Staff Briefing Papers

Company Northern States Power Company d/b/a Xcel Energy

Docket No. E002/M-25-142

In the Matter of Xcel Energy's 2025 Integrated Distribution Plan

Figure 6: Demand Response Annual Incremental Additions (MW)¹⁹

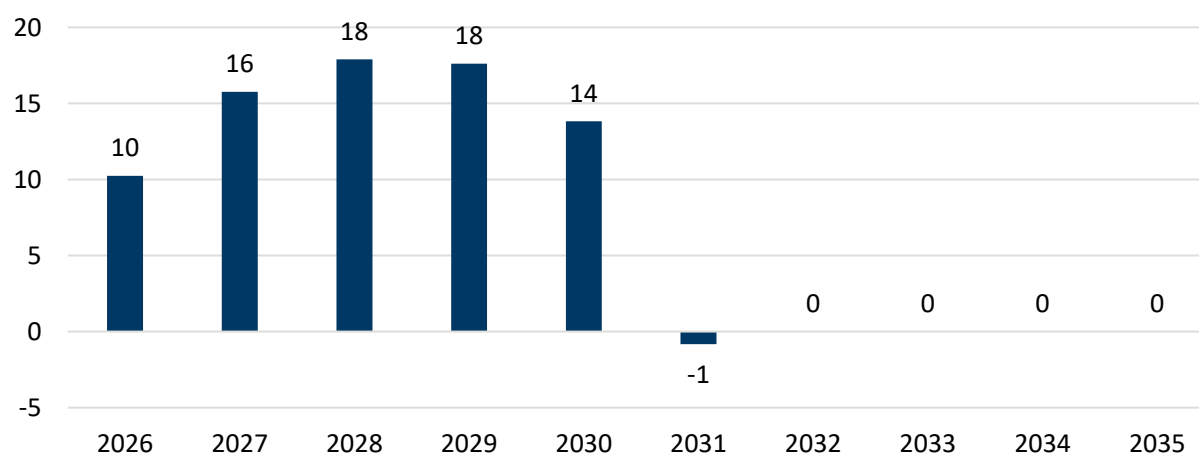
Fresh Energy commented that Xcel still does not include demand response in its substation or feeder forecasts and has made little progress on this issue. Fresh Energy pointed to identical paragraphs in the Company's 2023 and 2025 IDP describing its challenges incorporating demand response into its Distribution Planning. Fresh Energy expressed concern that Xcel would not be able to leverage cost effective DSM solutions to the rapid increase in capacity upgrades it anticipates over the coming years. Therefore, it recommended requiring Xcel to prioritize the integration of DSM into its distribution planning efforts.²¹

Xcel responded that while they agree that DSM and DR can be used to address localized needs, they were designed for bulk-system reliability. The Company added that their DR programs would require several days of advanced notice to be deployed and contrasted that to how distribution system conditions can change from hour to hour. Xcel stated to effectively and reliably use DSM and DR in the manner that requires full DERMS deployment and is a long-term goal that is several years away.

Fresh Energy disagreed that full implementation of DERMS is unnecessary before DSM can be integrated into distribution planning. Fresh Energy modified its recommendation to have Xcel submit a compliance filing in this docket within 6 months of the order that identifies non-DERMS changes the Company can make in the near term to better integrate DSM into distribution planning (**Decision Option 6**).²²

Fresh Energy requested to have Xcel file a compliance to identify non-DERMS changes the Company can include in the near term to better integrate DSM into distribution planning within six months of the order. Staff believes that there could be some benefit in gaining insight from the information this compliance order would provide although Xcel appears steadfast in its understanding that DERMS is a requirement for this DSM use case. While Staff agrees that using DSM and DR to help facilitate localized needs, Staff does not see this as a critical, near-term issue that requires an interim compliance filing. If the Commission is interested in this information, Staff recommends modifying **Decision Option 6** to require the information with the next IDP.

Figure 12: Forecast of Upgrade Costs 2026-2055, for TPS and HCA Cost Scenarios⁵²

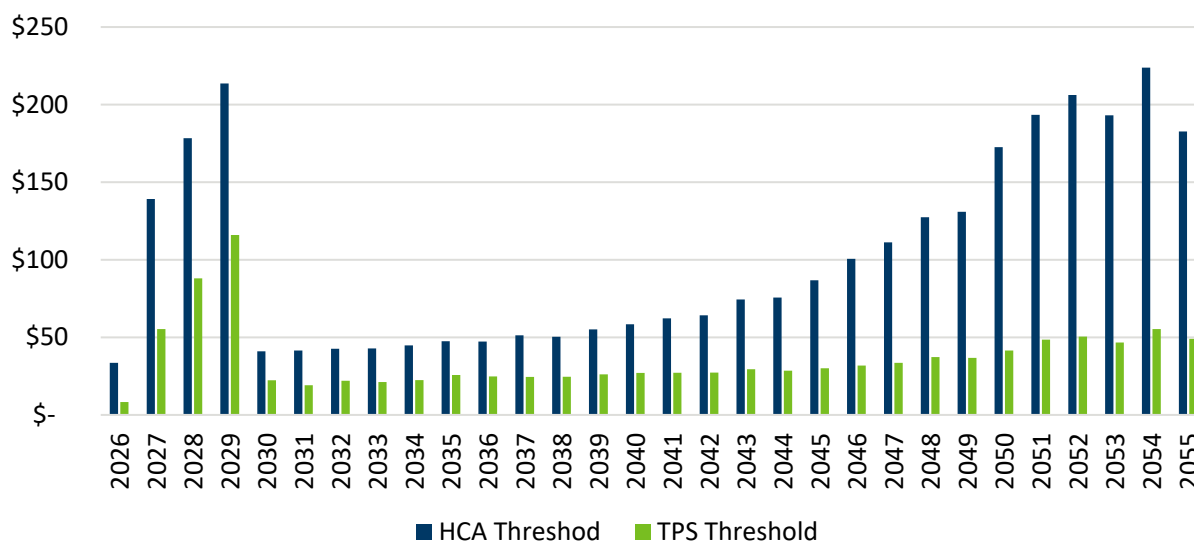
On forecasting distribution system upgrades costs, Staff notes that the forecasts have some assumptions that may increase the total estimate costs. First, Staff is not certain that \$800/kW of marginal capacity is an accurate or realistic value. The Company stated that it used both DSM modeling and its VPP settlement agreement in Colorado to derive that number. Staff questions this methodology as it does not appear close to market value of capacity seen in other interconnection proceedings such as the Distribution System Reactive Upgrade Process (DSRUP),⁵⁶ which is a market-driven cost sharing process for large distribution upgrades. In the stakeholder discussions that helped lead to a draft of the standards, some developers anecdotally stated that more than \$200-300/kW would price them out of interconnecting

Figure 28: Department Summary of Planning Standard Review and Approval Process¹⁸²

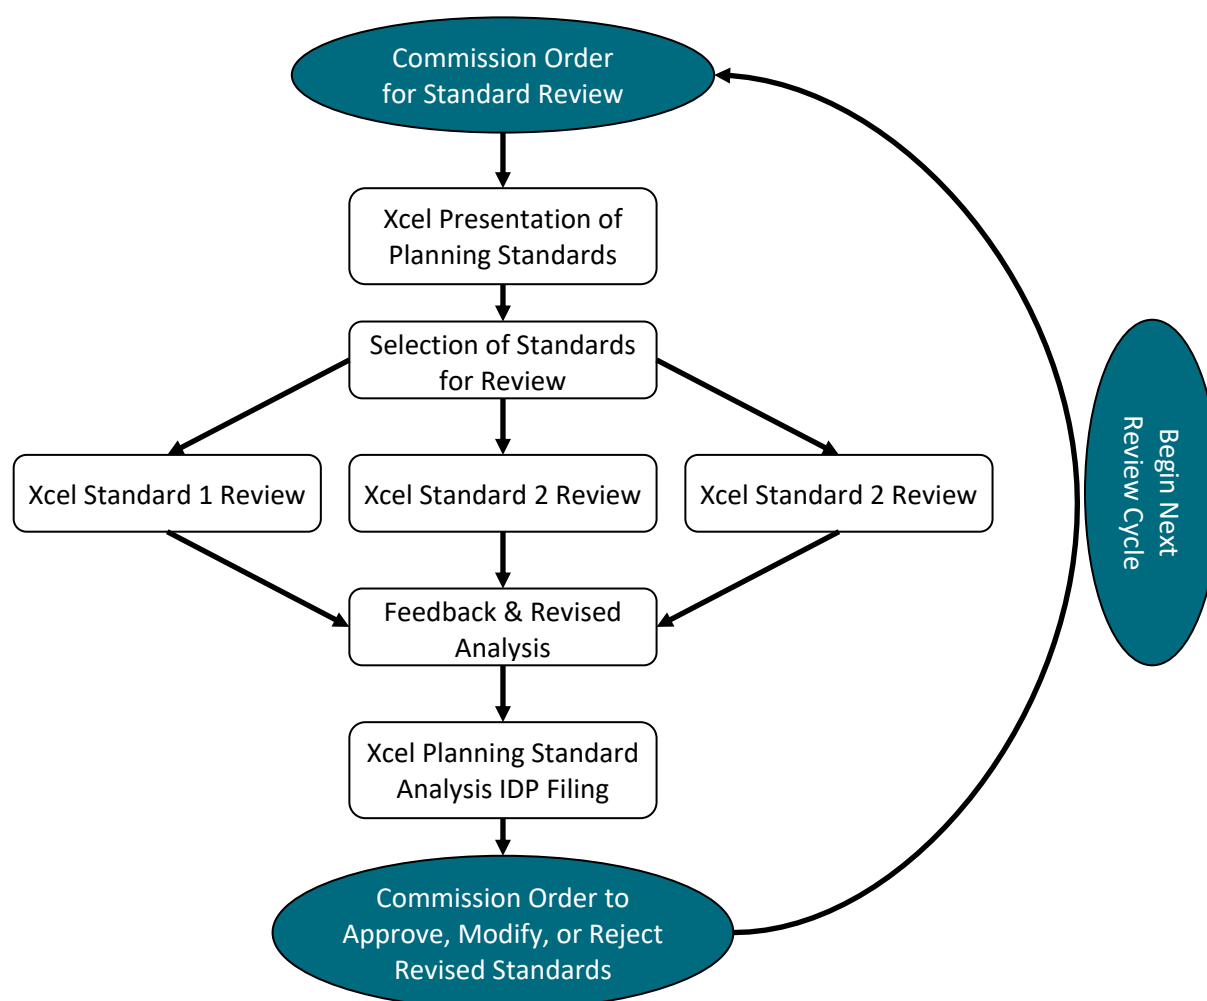
The Department also recommended requiring Xcel to file any changes to its planning standards in the IDP (**Decision Option 37**)

Figure 29: Xcel Energy Capacity Budget, 2018 – 2030 (\$M)¹⁹⁴

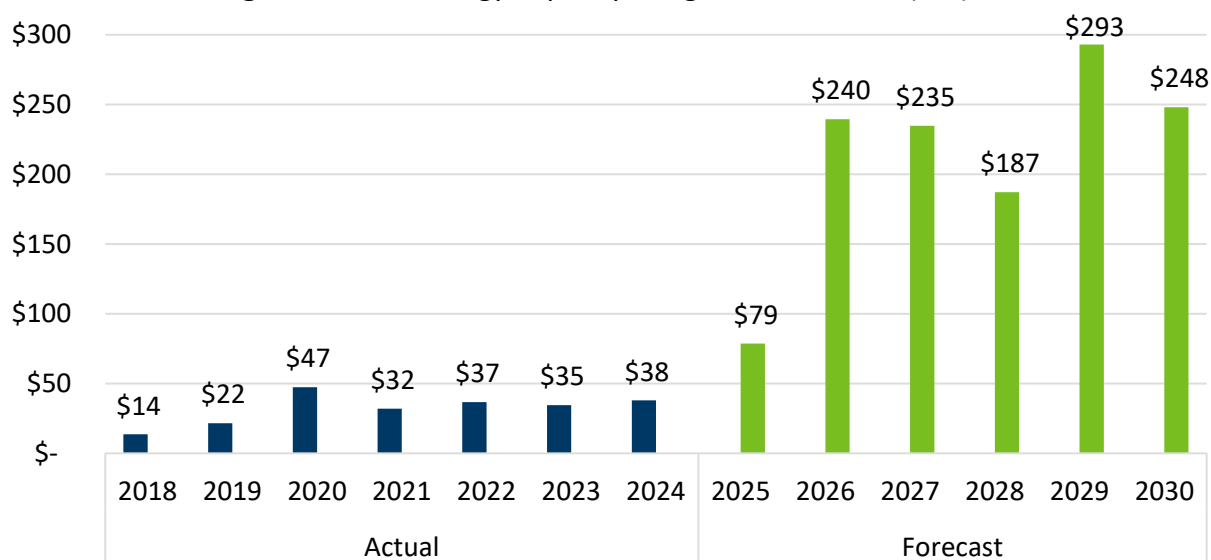
The Department raised concerns regarding Xcel’s capacity budget increase, which is predicted to rise from a total of \$240 million between 2019-2024 to \$1.21 billion between 2025-2030. The Department indicated it understood the primary driver of increased spending to be attributable to peak load growth.¹⁹⁵

Figure 35: Planned Net Loading Formula Applied to a Feeder N-0 Analysis

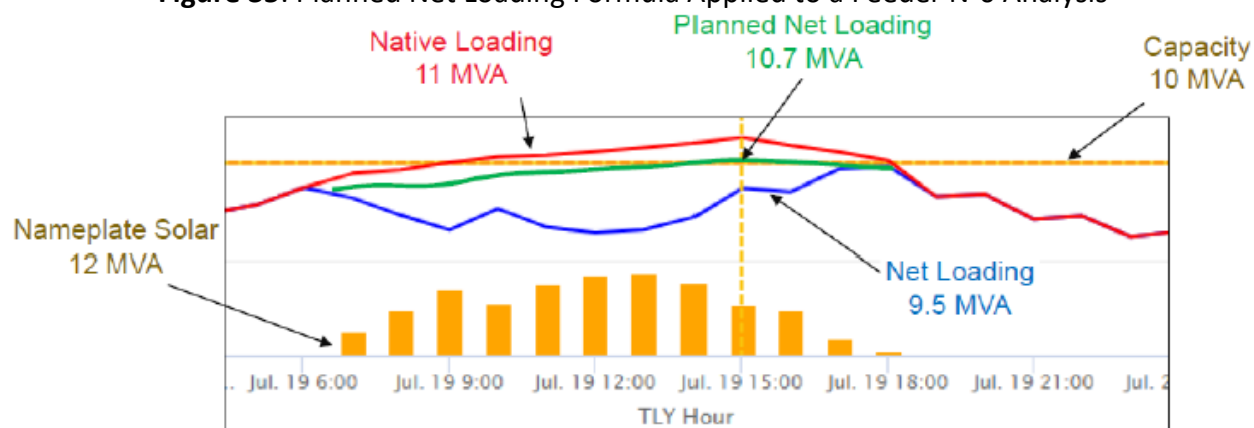
In this example the feeder in question has a capacity of 10 MVA. If load breaches this limit, Xcel quantifies it as an N-0 risk as it is overloaded. In the example Figure 35 above, native loading does breach 100% capacity at 11 MVA. Xcel's formula used Native Load, Net Load and the DF to determine that the 12 MVA of nameplate solar can reliably reduce system load by 0.3 MVA. Practically, this means that the feeder is still considered overloaded (since it must be less than 10 MVA) but the risk factor for the feeder is lower. This means that if Xcel must prioritize feeders to upgrade, this feeder upgrade could be somewhat deferred.³⁰²
